GUDE LANDFILL REMEDIATION

GLCC/DEP MEETING NO. 6

DATE: December 10, 2009
TIME: 7:30 PM to 9:00 PM
LOCATION: Montgomery County Transfer Station

Figure 7. PROPOSED GROUNDWATER MONITORING WELL LOCATION MAP
SCALE: 1"=500'

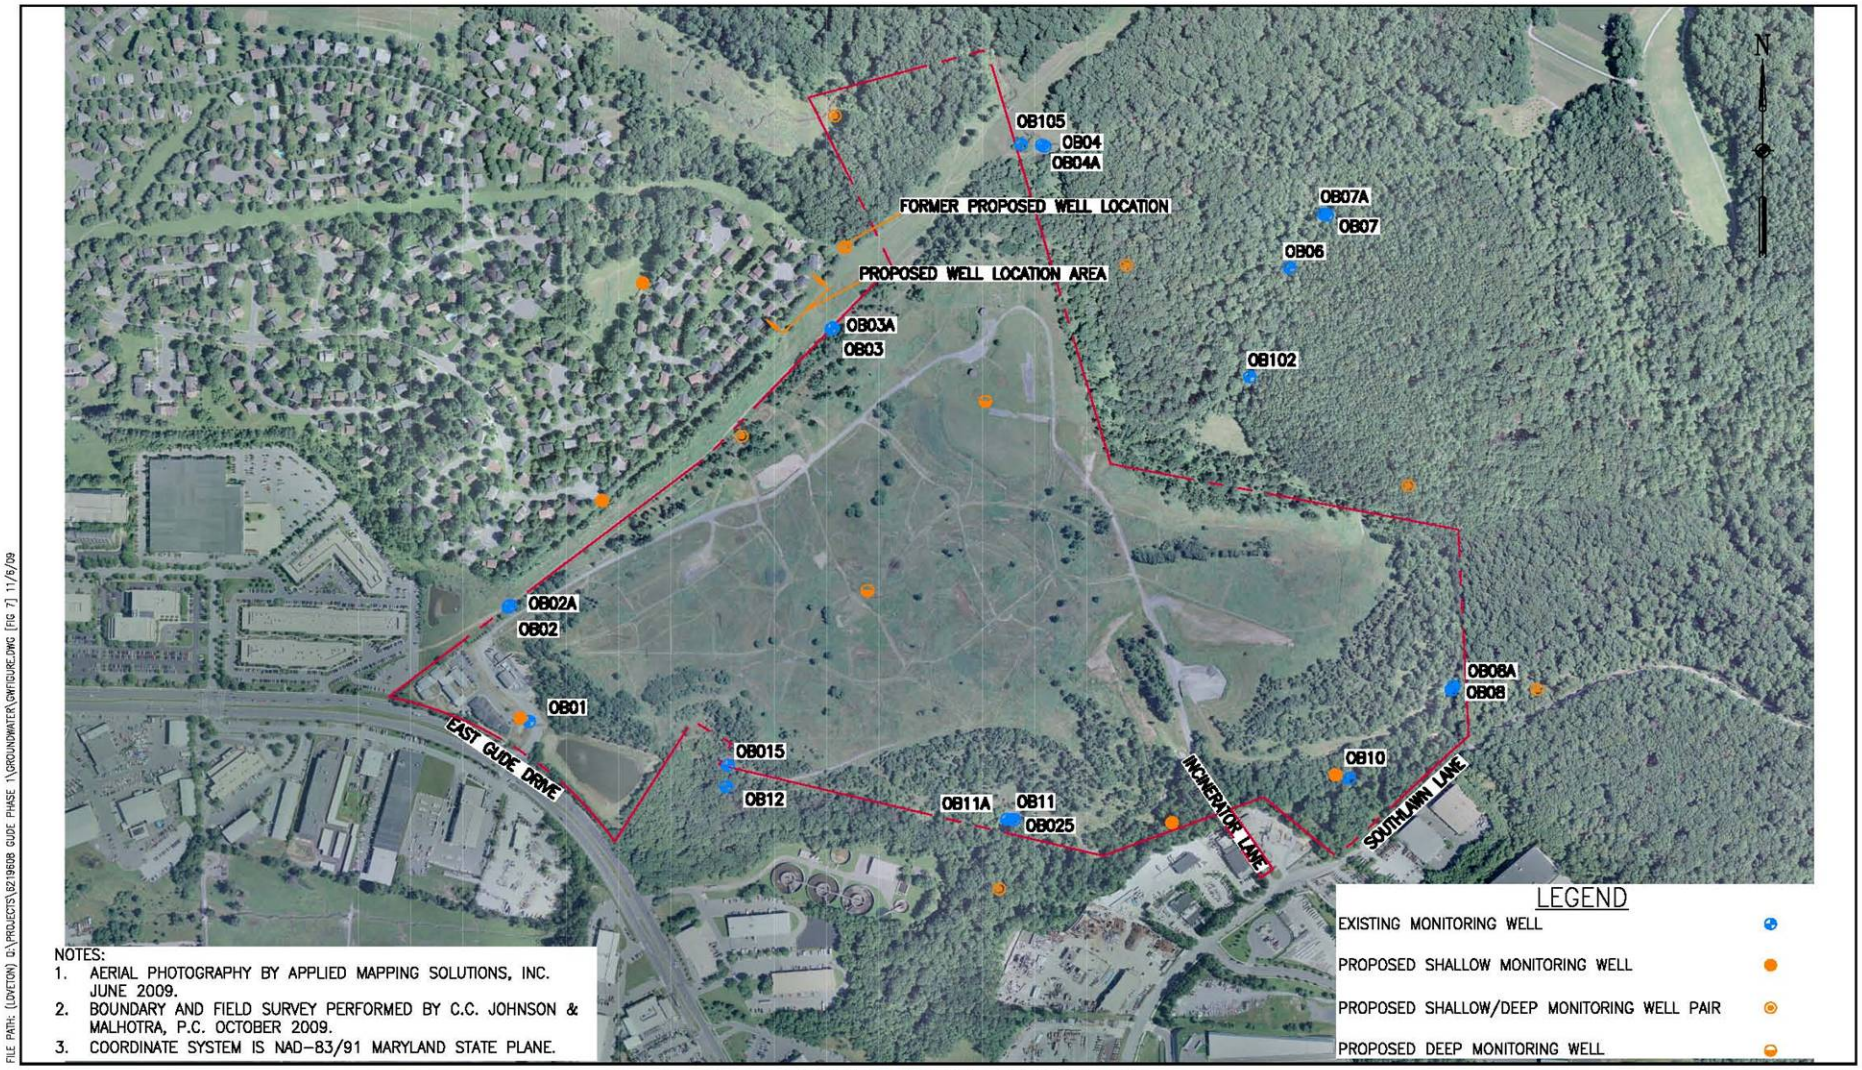
3) Pete Lekas of EA presented the Proposed Groundwater Monitoring Well Location Map and discussed the reasons for the proposed new monitoring locations, including new monitoring wells on the landfill itself, on WSSC property, on M-NCPPC property, and within the Derwood Station South Community. The proposed monitoring well location map and well drilling photos are included as Attachment 3.

6) Bob Day of GLCC commented that the water surface elevation in existing monitoring well OB03 is above the elevation of some of the Derwood property elevations.

8) GLCC, the County and EA discussed the possible locations for the monitoring wells in the community with respect to advantages and disadvantages. For example placing wells in common areas versus on county property, such as in the center of the paved courts. The final locations will need to be field located and will depend largely on the best approach for avoiding underground utilities, obtaining permitting approvals, and minimizing disturbance to the Community.

6-02 – DEP and EA to finalize more precise locations of the new monitoring wells. Follow-up work with permitting agencies, utility locators, and adjoining property owners will be conducted.

TYPICAL MONITORING WELL CONSTRUCTION DIAGRAM
(FLUSH MOUNT)

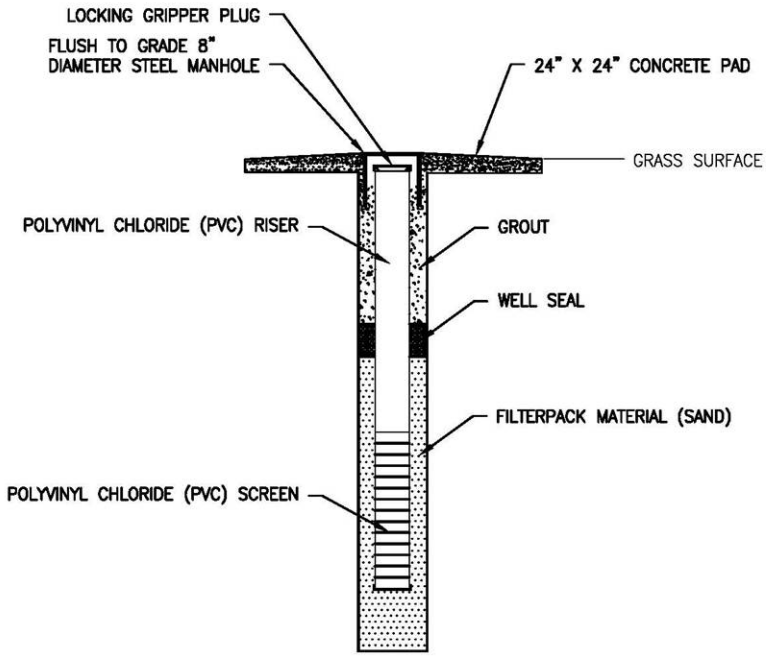
9) Pete Lekas explained how the monitoring wells, if placed in some of the paved courts, would be flush mounted and sealed to prevent contamination from stormwater runoff.
